DAUPHIN COUNTY SUBDIVISION/LAND DEVELOPMENT REVIEW REPORT

Municipality	<u>West Hanover Township</u>		Surveyor	<u>Cornerstone Consulting</u>		Engineer	<u>Cornerstone Consulting</u>	
Plat Title	<u>Wendy's Linglestown</u>							
Zoning District	<u>Neighborhood Commercial (NC)</u>			Proposed Land Use	<u>Residential</u>			
Plat Status:	<u> </u> Preliminary	Plat Type:	<u> X </u> Subdivision	Regulations:	<u> </u> County			
	<u> </u> Final				<u> X </u> Municipal			
	<u> X </u> P/F		<u> X </u> Land Development		<u> X </u> Zoning			
	<u> </u> Minor				<u> X </u> S&LD			
Existing # of Lots	<u> 1 </u>	Proposed # of Lots	<u> 1 </u>	Proposed # of New DUs	<u> 1 </u>	Subdivided / Developed Acres	<u> 1.03 </u>	Total Acres <u> 1.03 </u>
Date Received	<u> 03/07/24 </u>	Staff Review	<u> 03/20/24 </u>	Official County Review	<u> 03/20/24 </u>			
Reviewed by	<u> BW </u>	Checked by	<u> </u>	Tax Map Parcel #	<u> 68-020-028 </u>

Plan No. 24-026

SHEET NAME	
COVER SHEET	
SHEET NUMBER

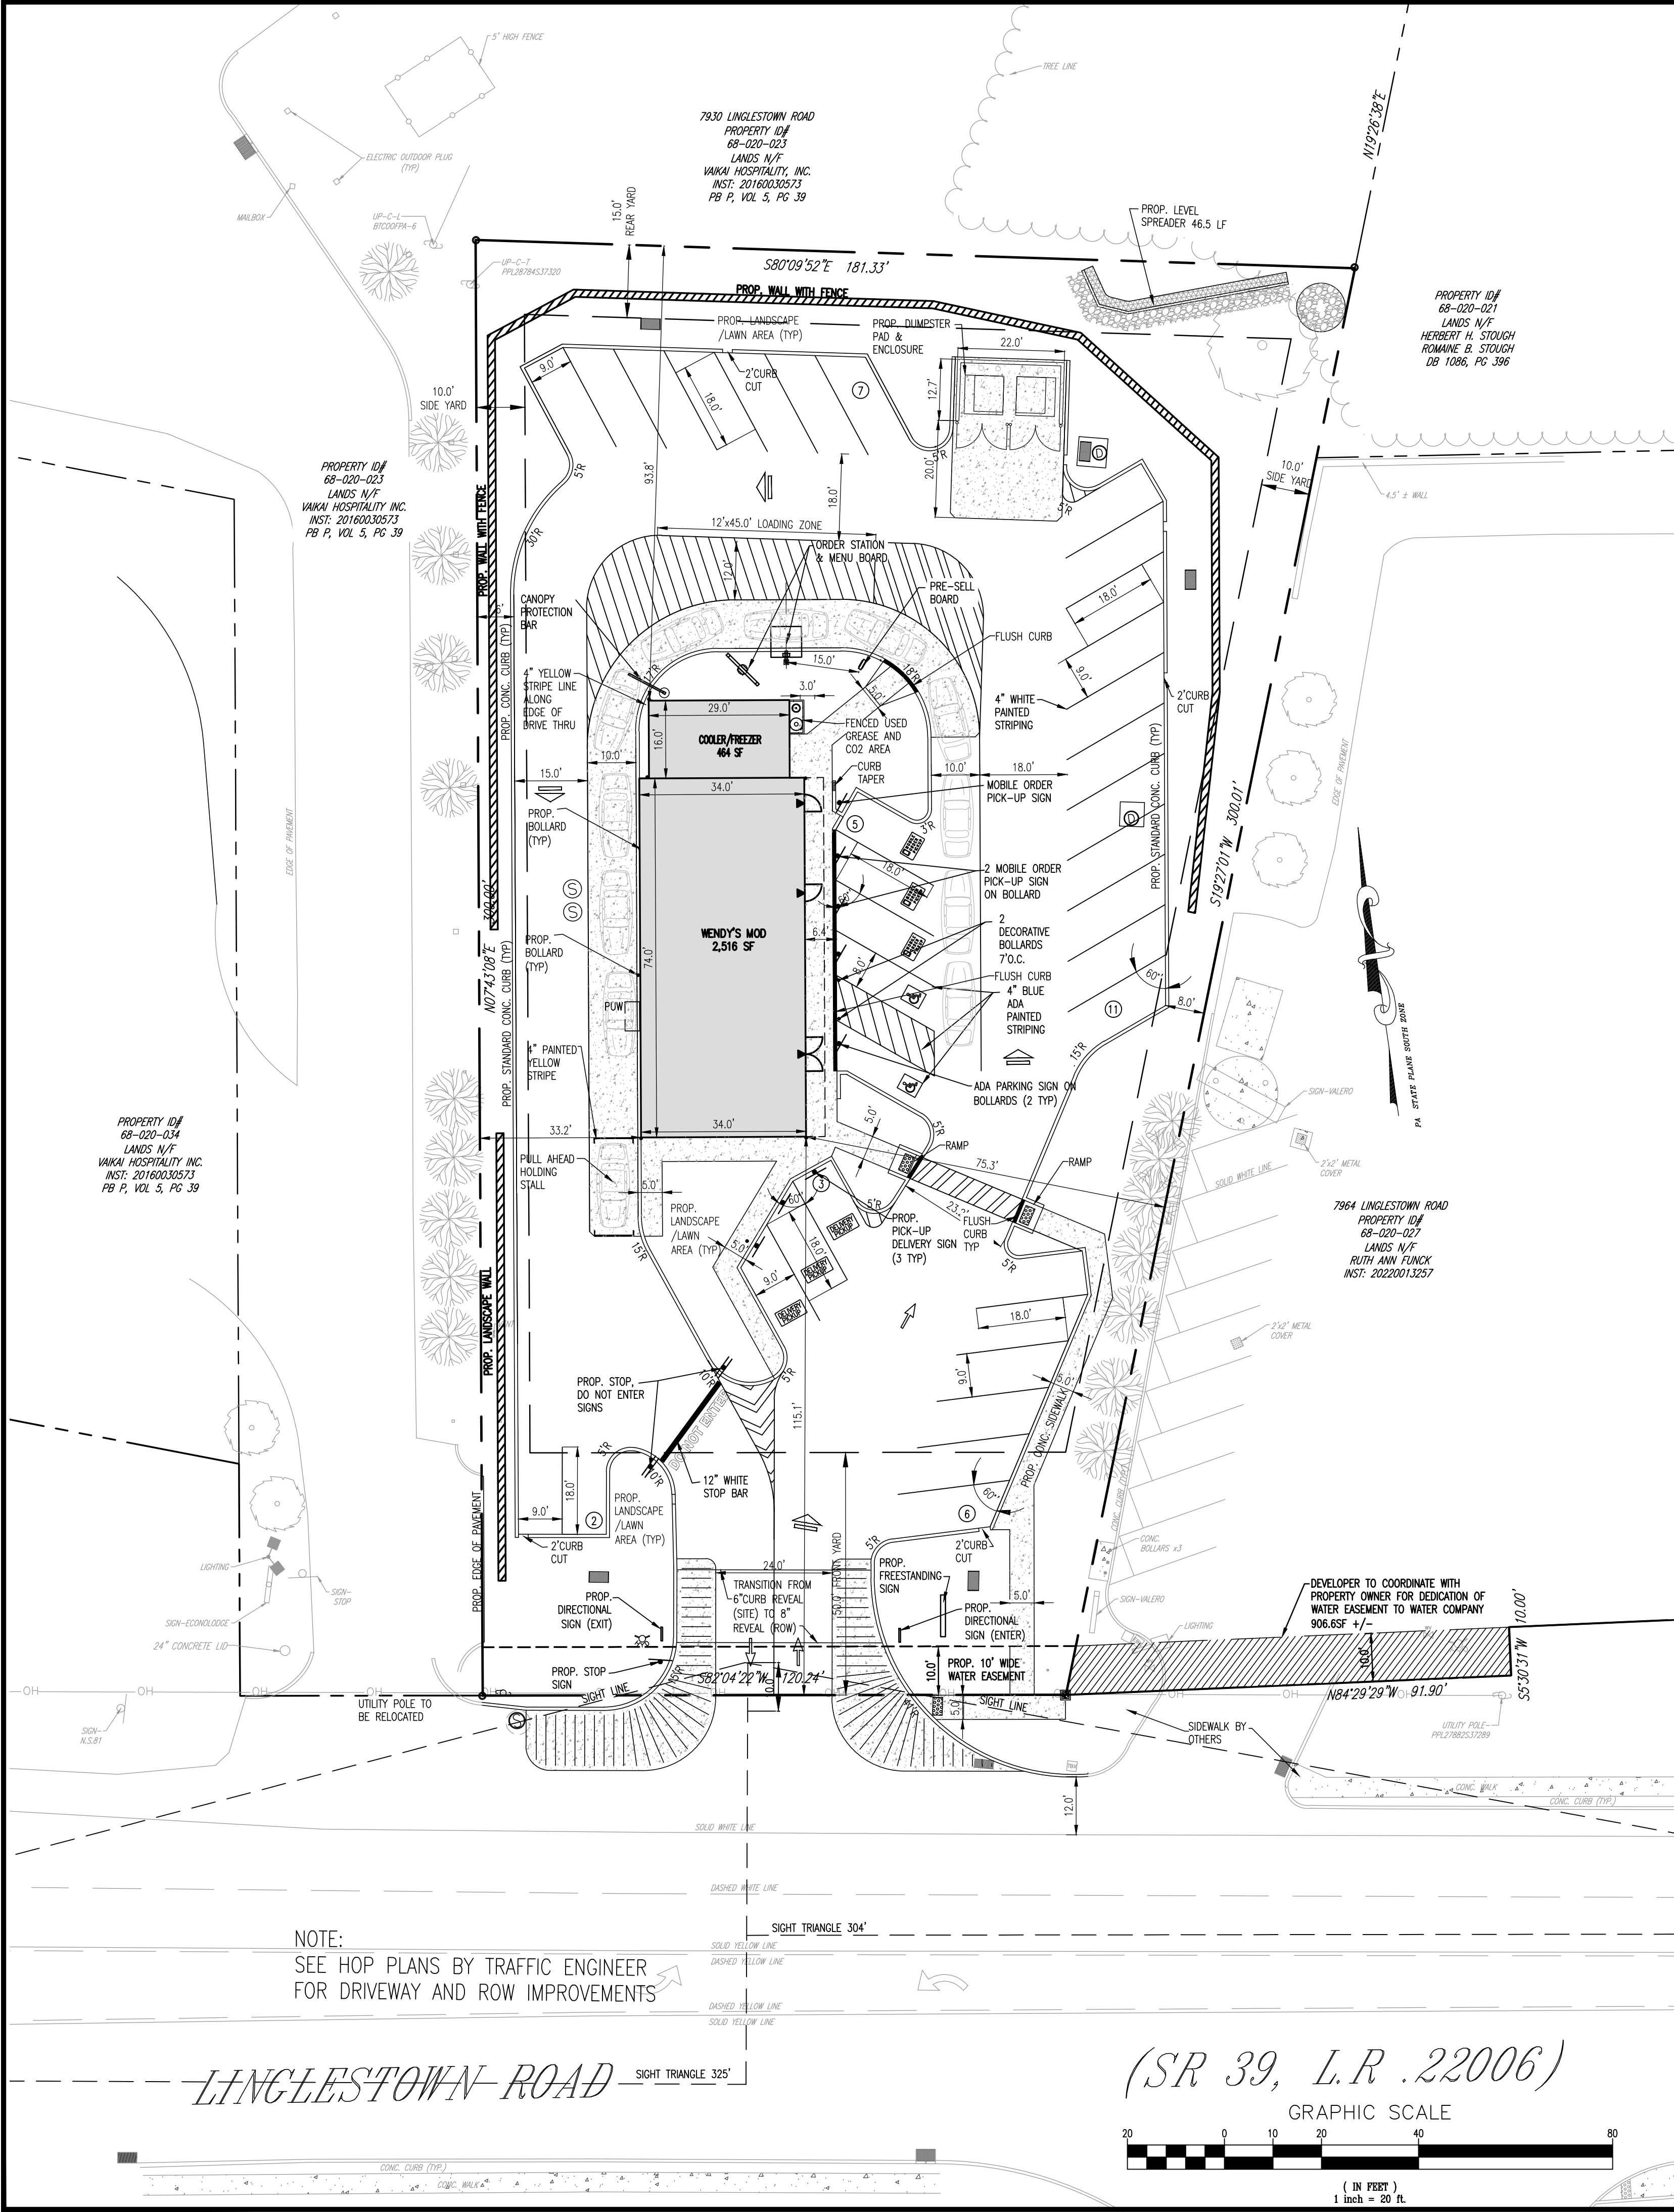
10. Is the plan being submitted as a Preliminary or Final plan or a Preliminary / Final? If it is submitted as a Final Plan, has the appropriate waiver been requested for the Preliminary Plan requirements? Clarification on what the plan is submitted as could be displayed on the cover sheet for reference.

SHEET NAME
SITE PLAN

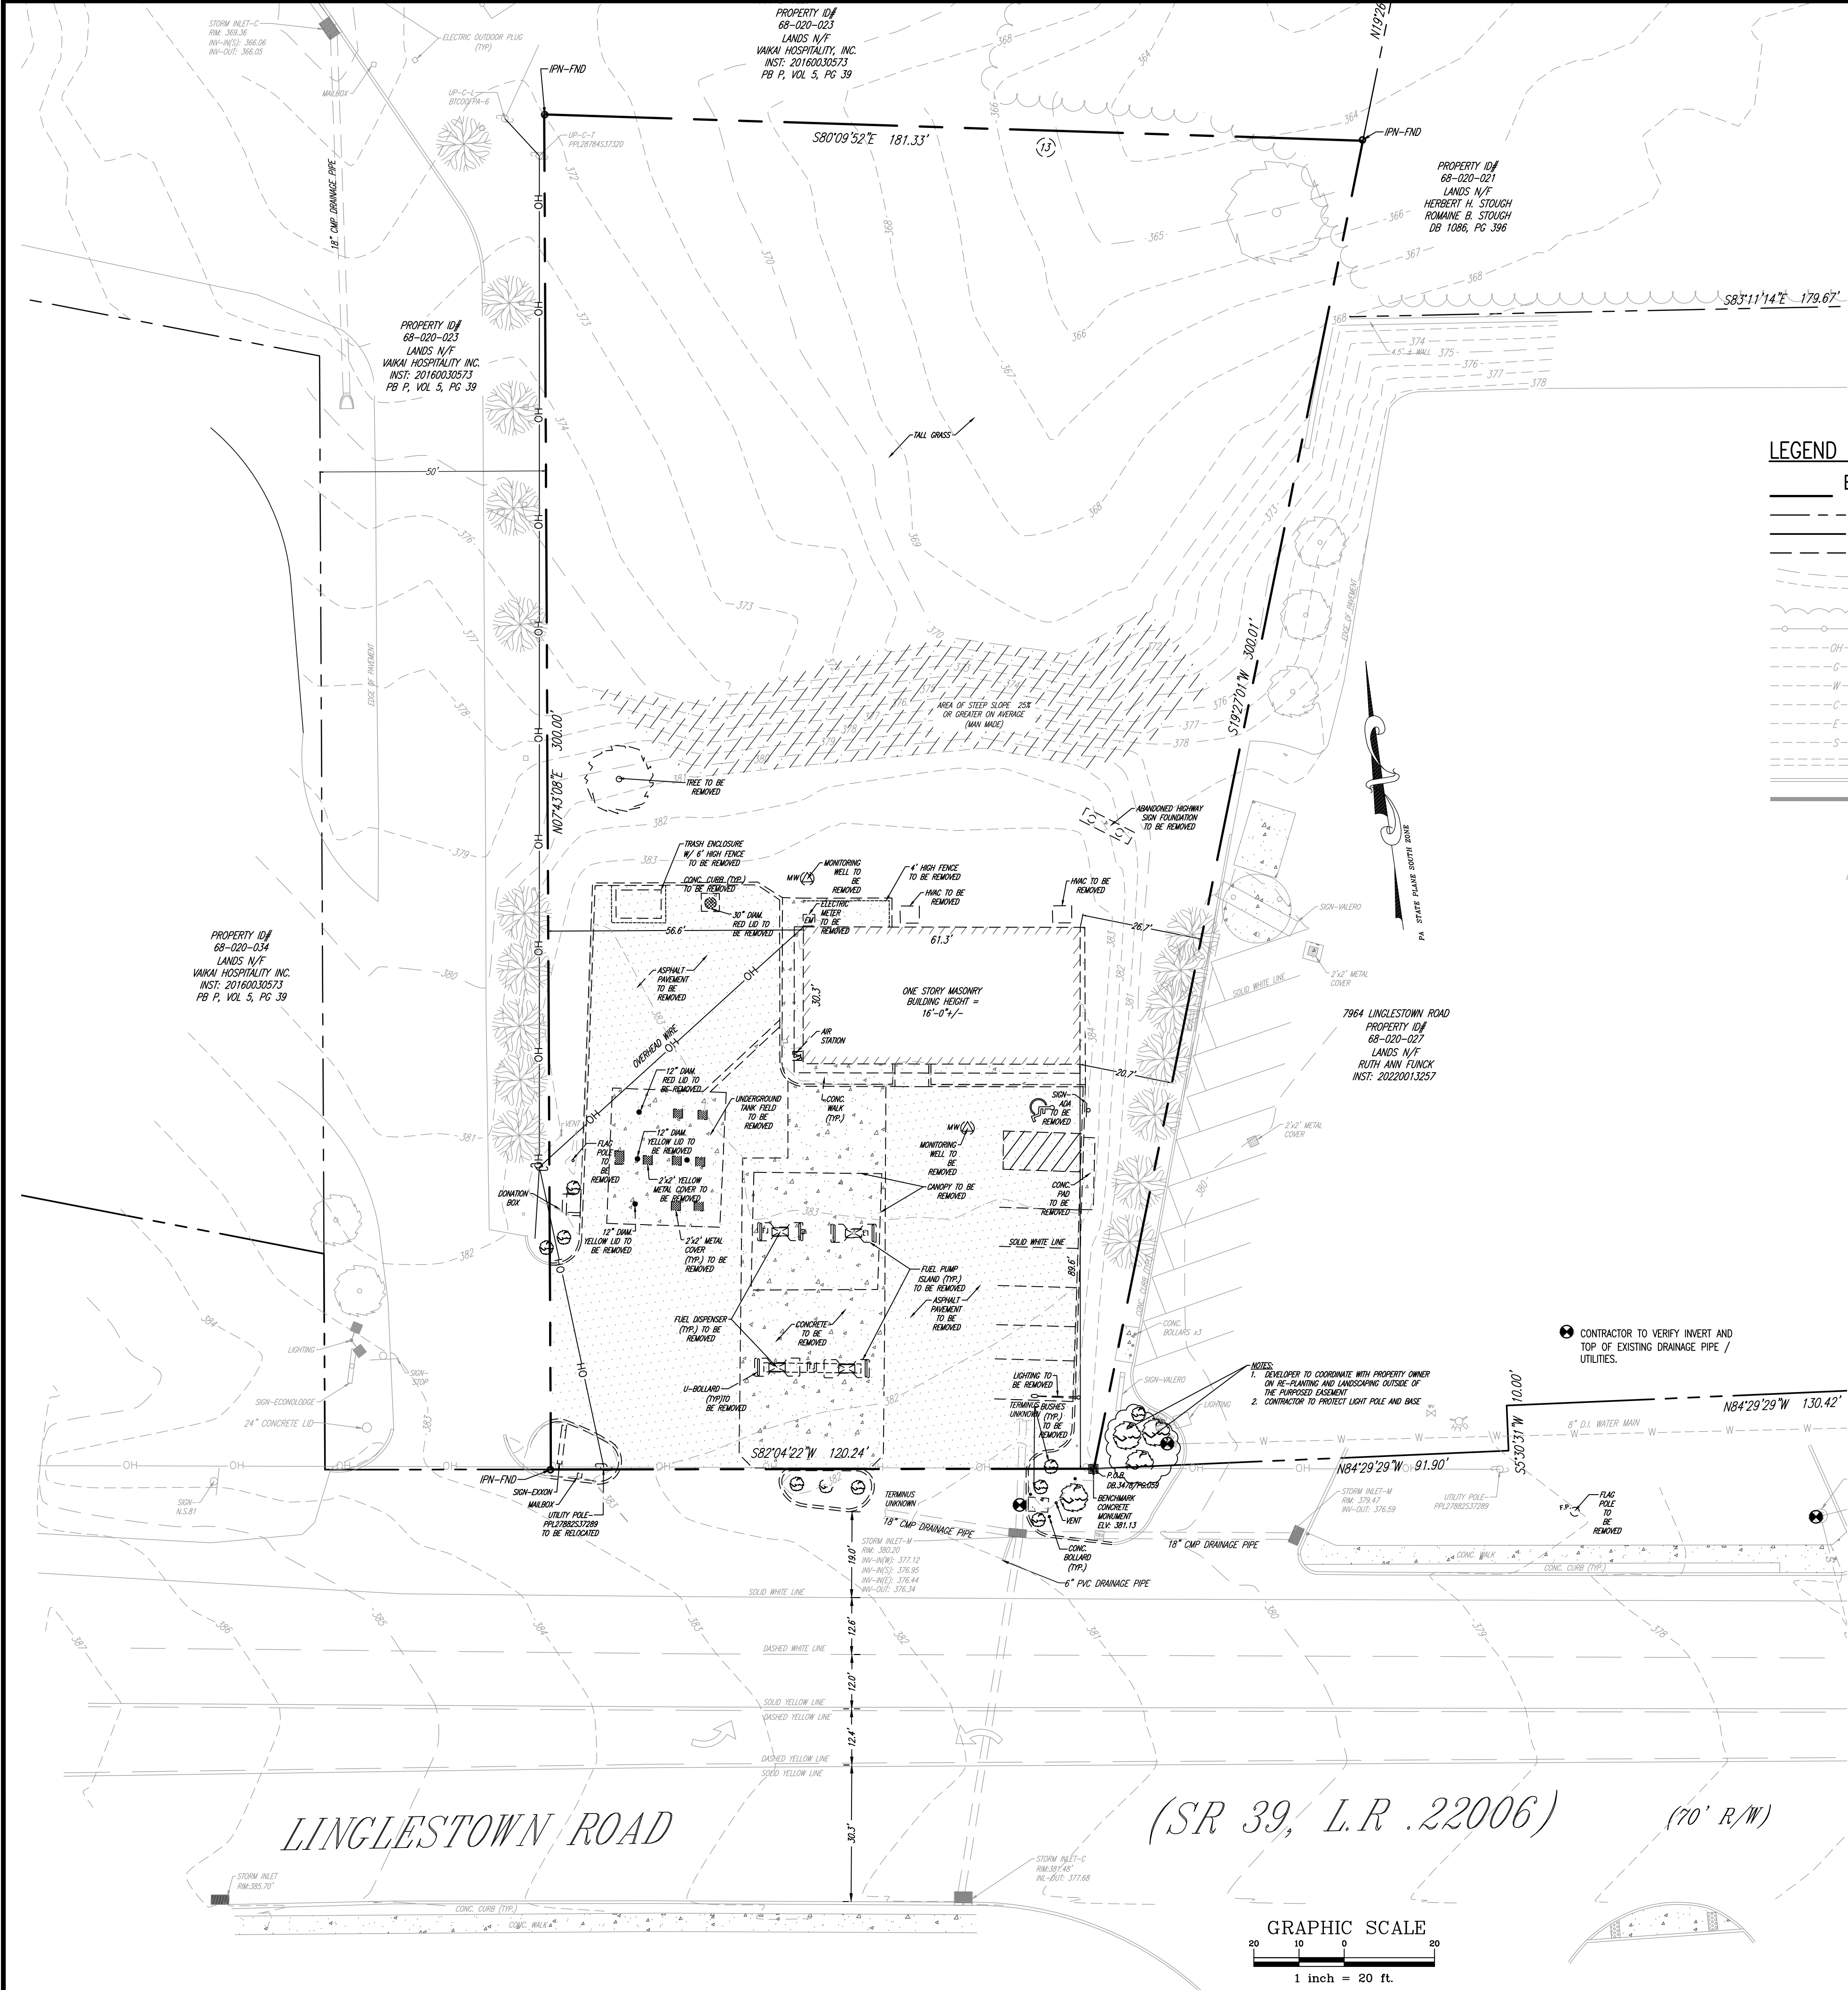
6. Sidewalks appear to only be located on the eastern side of the access point of the site. It is recommended that sidewalks also be installed along the western side of the site along S.R.0039. [S-LD §173 – 27]

9. What use was the total proposed parking spaces derived from? Was it based off the "Eating Places" use? If 30 spaces are required, what is the additional need for the 4 spots to have 34 total proposed spots? Has a parking schedule been submitted to the township to ensure adequate but not excessive parking is proposed? [S-LD § 195-418-D-1]

11. The ADA / Handicapped parking spaces that are located along the building could become inaccessible if the drive thru backs up passed the handicapped parking spaces. To ensure the Handicapped parking spaces are always accessible and not blocked, it is recommended they be moved to where the "Delivery Pick up" spaces are instead of beside the "Mobile Order Pick-up." Moving the Delivery Pick up spaces beside the Mobile order pick up would allow for safer access to the ADA spaces.

12. Has a lot circulation plan been completed to ensure traffic will flow efficiently through the site? It appears there could be access issues to the "Mobile Order Pick Up" spots due to them becoming blocked by the Drive-thru line. Is there an alternative spot on the site to locate these parking spaces?
